Date: April 1st, 2011

Project #: EP – 0033 – C01

Description: Emergent Project – East Orange
Whitney Houston Academy
Roof & Ceiling Renovations
Addendum # 01

DATE: 05/11/11
 DRAWING NO: T01
 SHEET NO: 1 OF 1
 TITLE SHEET

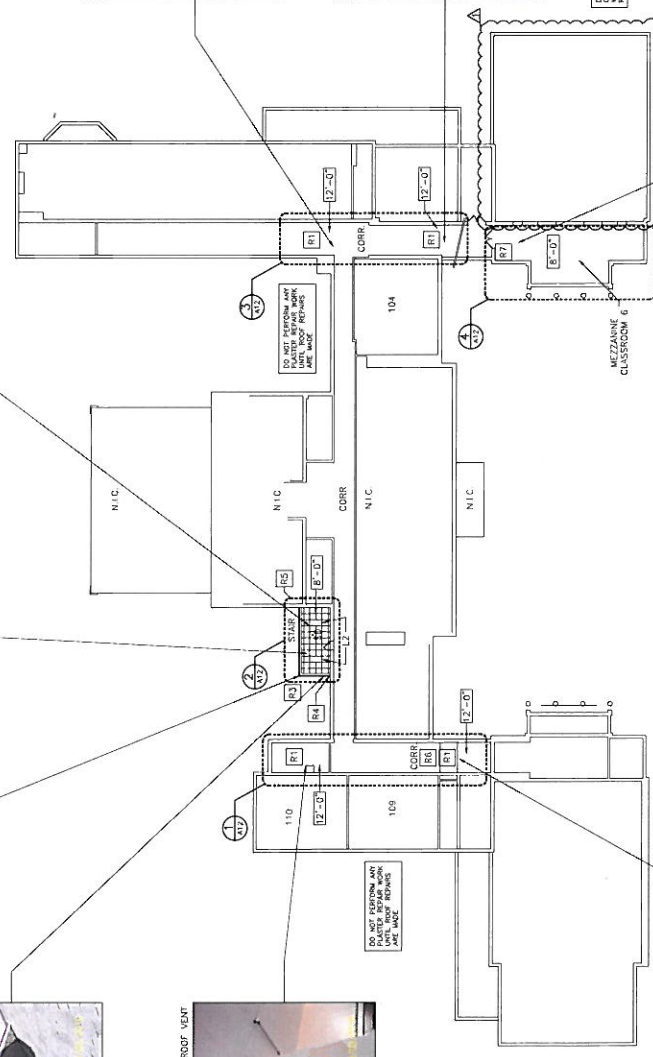
- a. Wall and Ceiling Plaster :
Approximately 780 square feet of rough coating wall and ceiling plaster located throughout the subject building.
4. The removal and replacement of Gymnasium ceiling work has been deleted from Drawings T-01, A-11, A-12, E-10 and Figure -1 Combination Floor Plan - Asbestos Removal Map.
